Public comments received by email as of 12 pm on August 27, 2012
For the Charles Avenue Project

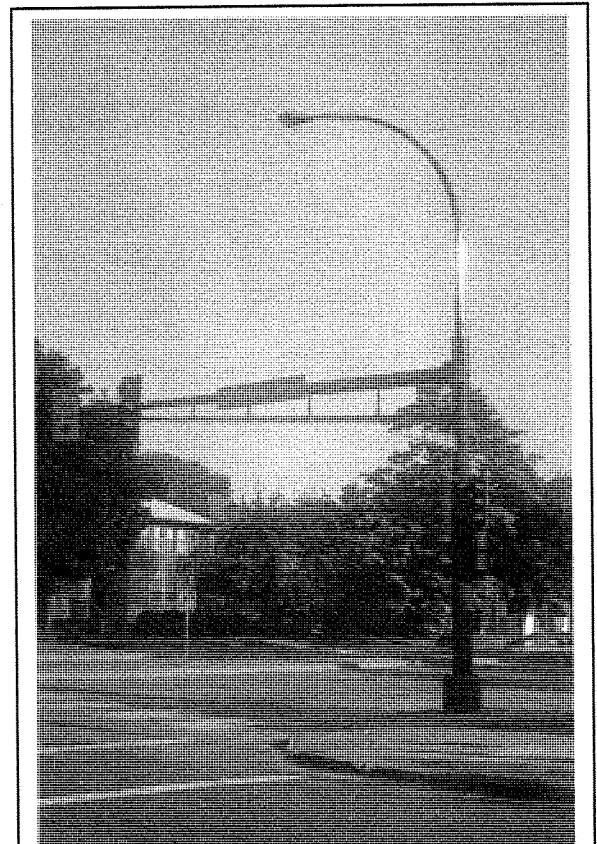
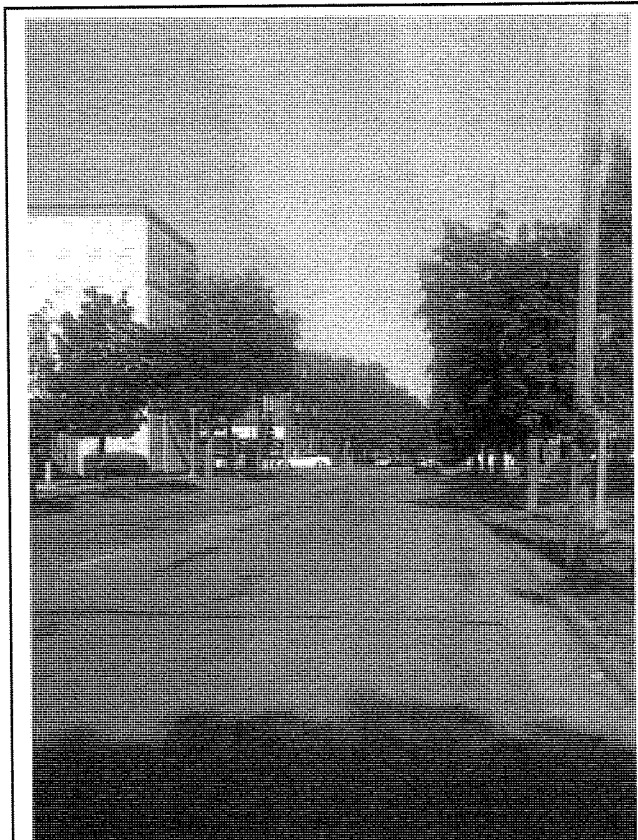
Go north on Asbury from Charles to
Thomas Avenue which is just two blocks
north of Charles with a lighted intersection.

Here,
Snelling
Ave. is
just
One
block
West of
Asbury.

This
Already,
Offers a
Safe
Bike/Ped.
Traffic
Light
Inter-

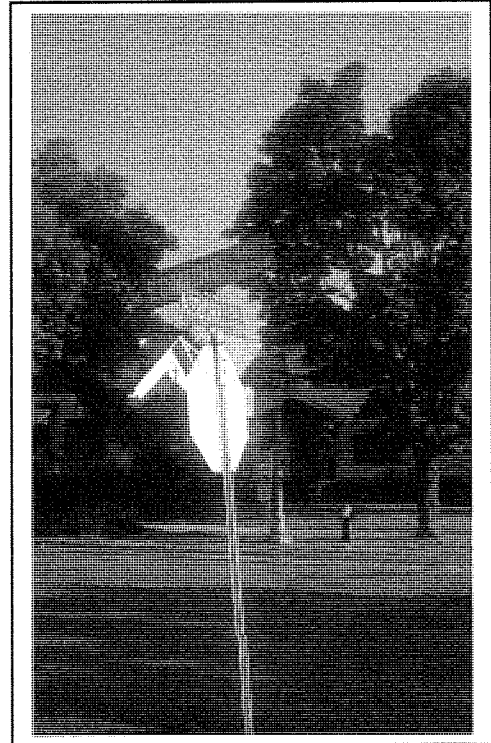
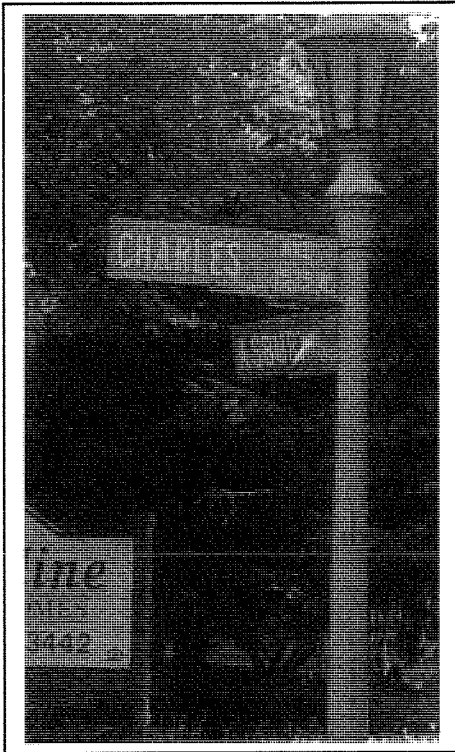
Option #2) Re-direct the bike/pedestrian path north from Charles Avenue onto Asbury Avenue
Just (1) one short block north, to Edmund Avenue. Snelling Ave., this Snelling Avenue intersection has a widened median this intersection is already blocked from vehicular traffic turning east or westbound from Snelling Avenue. Then, Cross over Snelling Ave., at Edmund Ave., then continue to Aldine (2 blocks west of Snelling Ave.)

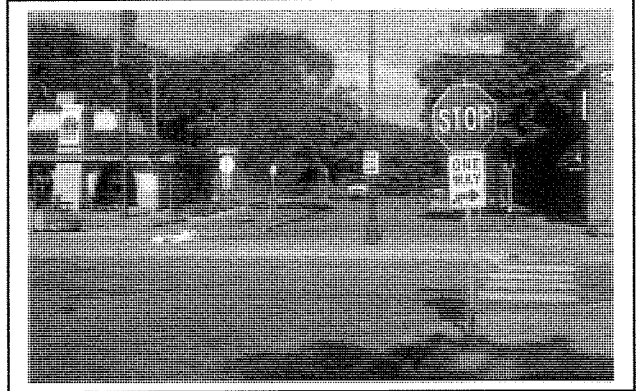
Turn north one block from Charles on Asbury
To Edmund

Edmund is a short "One Block" length
east/west street between Asbury and Snelling

Looking from Asbury west onto Edmund with
Snelling Ave. one block to the west from Asbury.
* This residential street is only one block in length
between Asbury and Snelling Avenue.

Option #4)

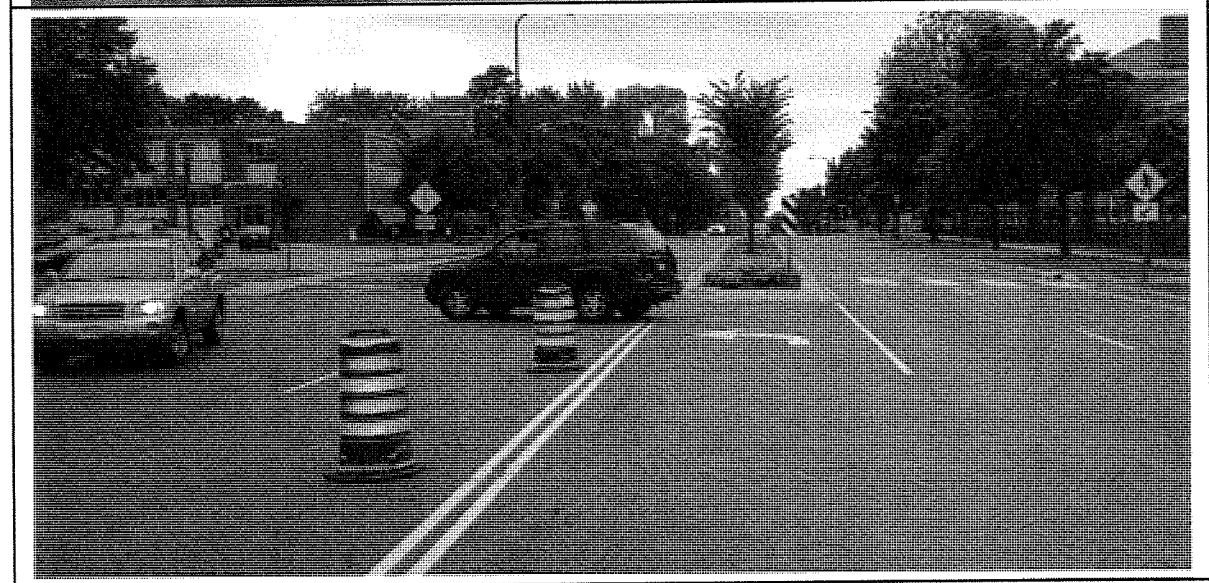
Compromise:

Bike & Pedestrian Crossing goes across Snelling Avenue at Charles still allows all Snelling Ave. southbound cars from the points north of Charles Ave., to turn left, onto eastbound Charles Avenue.

Construct only one (1) pedestrian crossing on the south intersection area.
